# ENVIRONMENTAL RE-EVALUATION FORM

Project Name: I-20, I-26, I-126 Carolina Crossroads Corridor Improvements

# NEPA Re-evaluation

SUPPORTING DOCUMENTATION  
JULY 22, 2020

**FIGURE 5.1  
ROW CHANGE  
PHASE 2  
PARCEL 187**

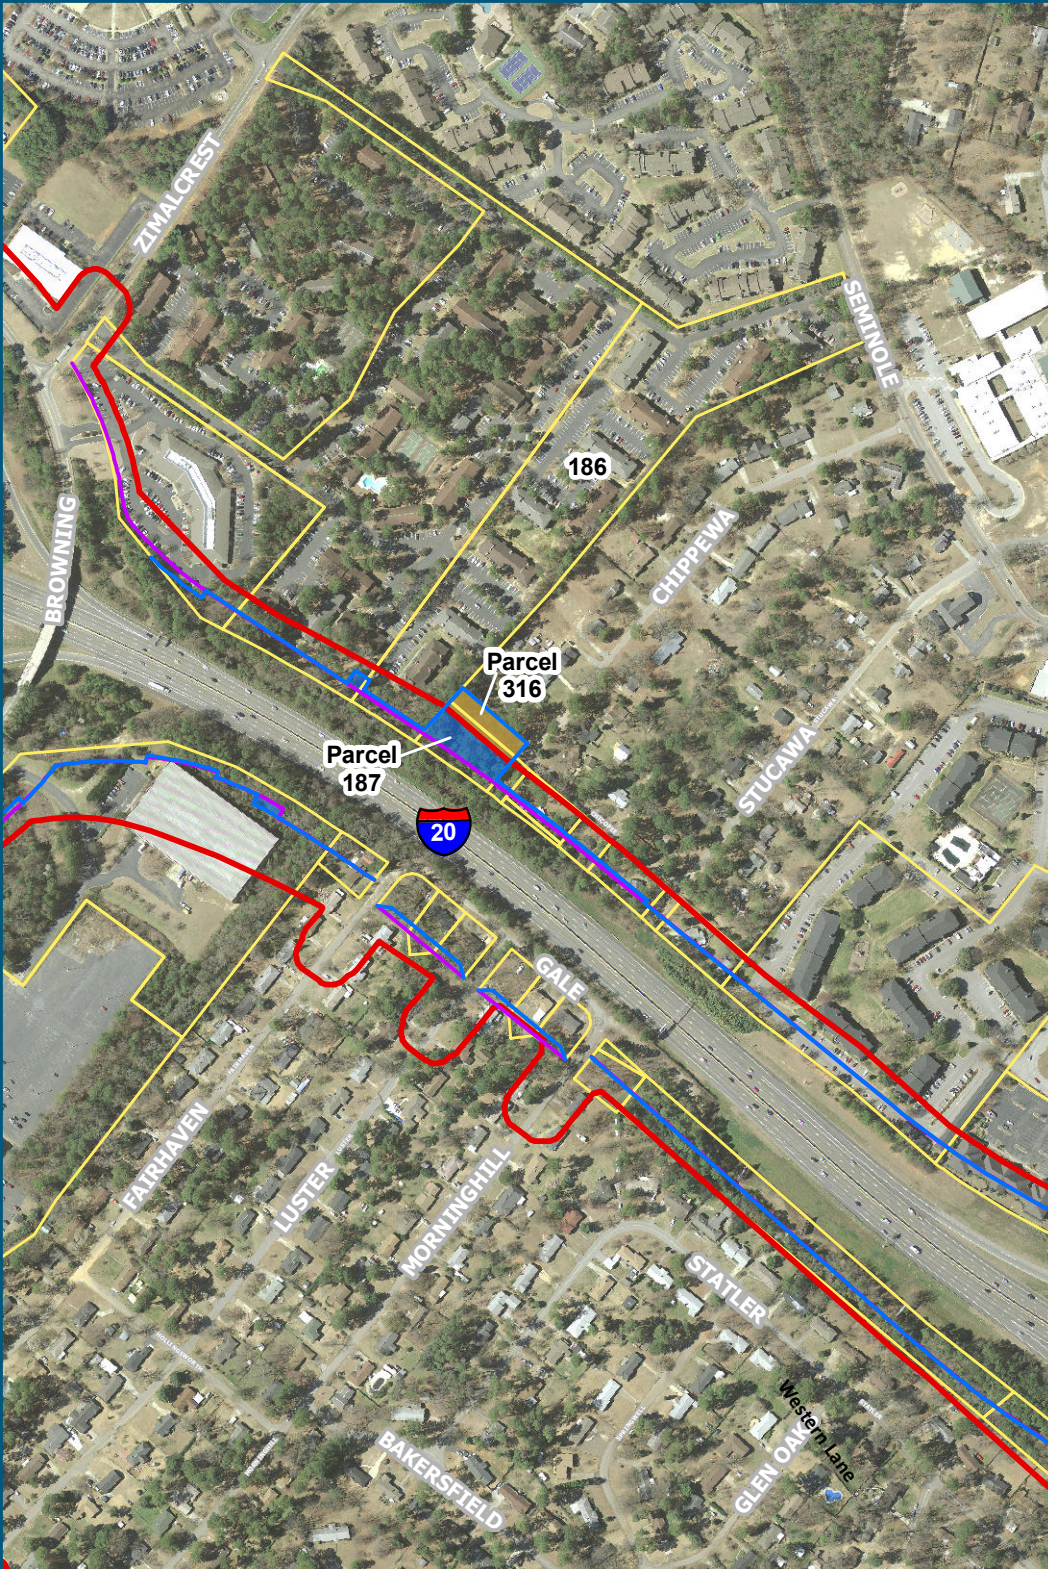
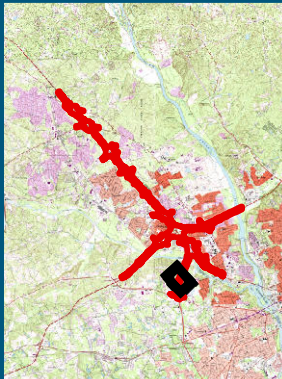
**Parcels 187 and 316** are adjacent to each other and are located in a wooded area in a residential neighborhood, to the west of the intersection of Chippewa Drive and Chicopee Drive. The portion of the parcels that is outside of the original archaeological study area is approximately 0.3 acres. Due to ongoing ROW negotiations, no shovel tests were excavated at Parcels 187 and 316. It is recommended that archaeological investigations be conducted in the uplands portions of Parcels 187 and 316. The area is heavily wooded and includes a stream and associated wetlands in the central portion, with uplands to the east and west. This system appears to be part of Wetland 15. It is recommended that a delineation be performed after acquisition.

As currently proposed, the design would not impact wetlands on this parcel; however, if the design-build contractor proposed an alternate design that did impact wetlands at this location, those impacts would be documented in a re-evaluation and USACE Individual Permit (IP) modification.

Figure 1. Updated Impacts in northern half of NSA X

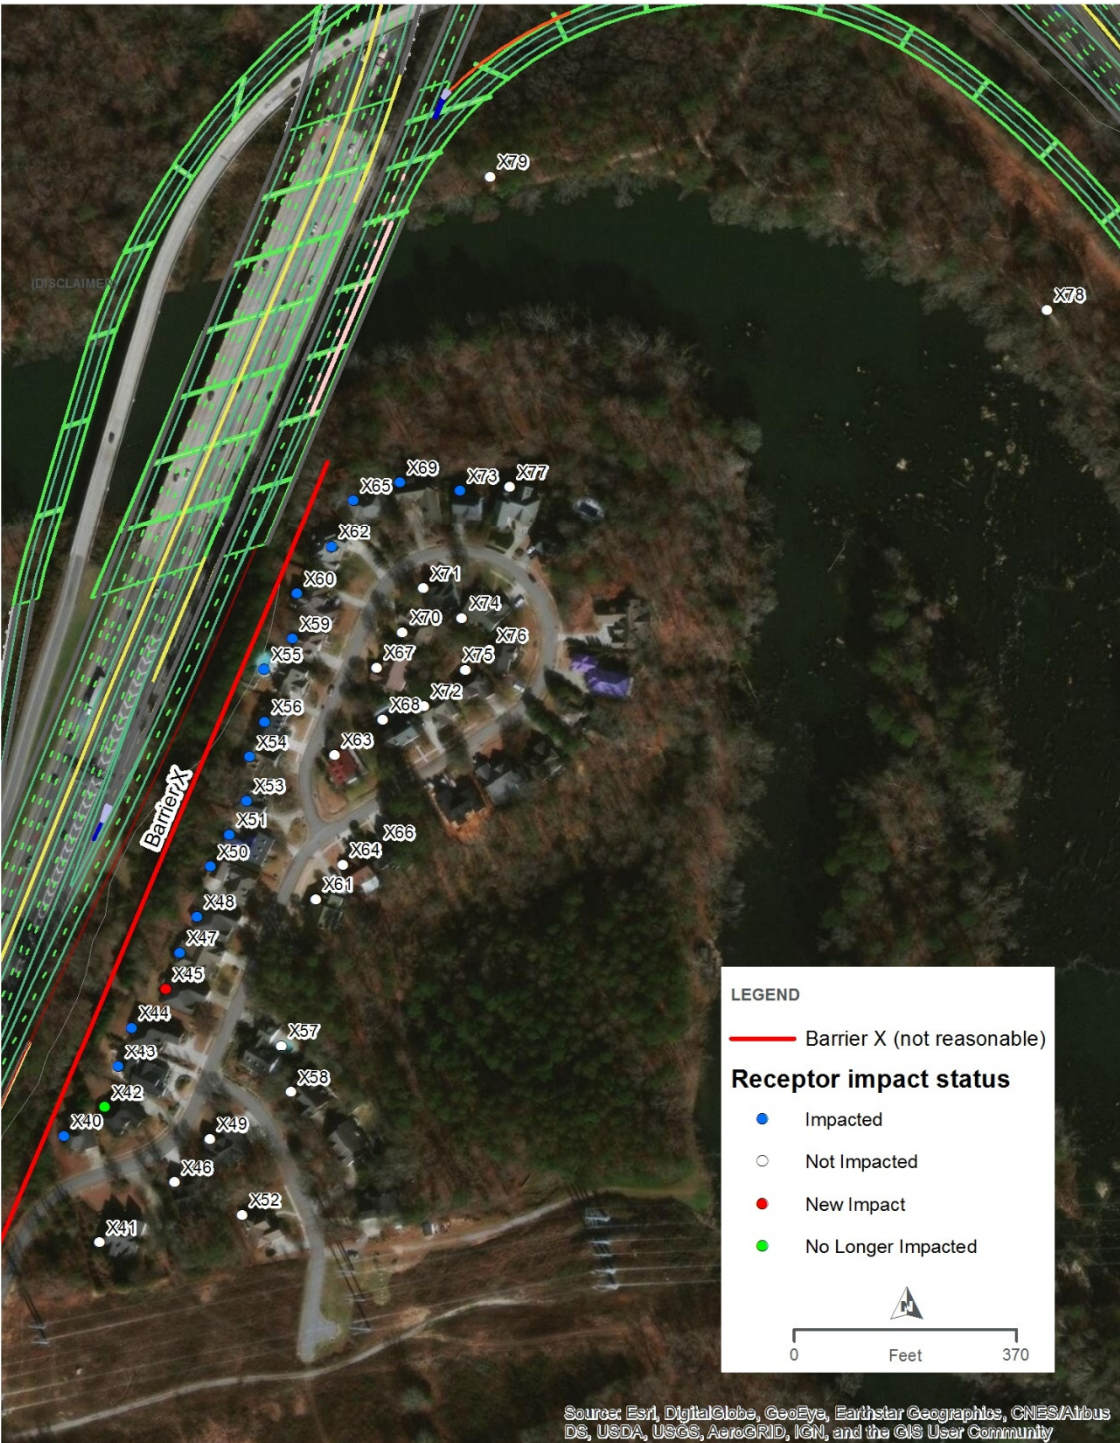
The largest increase in build noise levels was 1.8 dB, and the largest decrease was 1.7 dB. Two receptors changed impact status: X42 changed from impacted to non-impacted, and X45 changed from non-impacted to impacted. Therefore, the overall number of noise impacts in the project remains the same. The updated impact information is shown in Figure 1 below.

Due to design changes in the vicinity of NSA X, the noise analysis in that area was updated, including the build model and the barrier analysis. No change greater than 2 dB was observed. One receptor changed impact status from non-impacted to impacted, and one receptor changed impact status from impacted to non-impacted. The barrier status remains not reasonable.
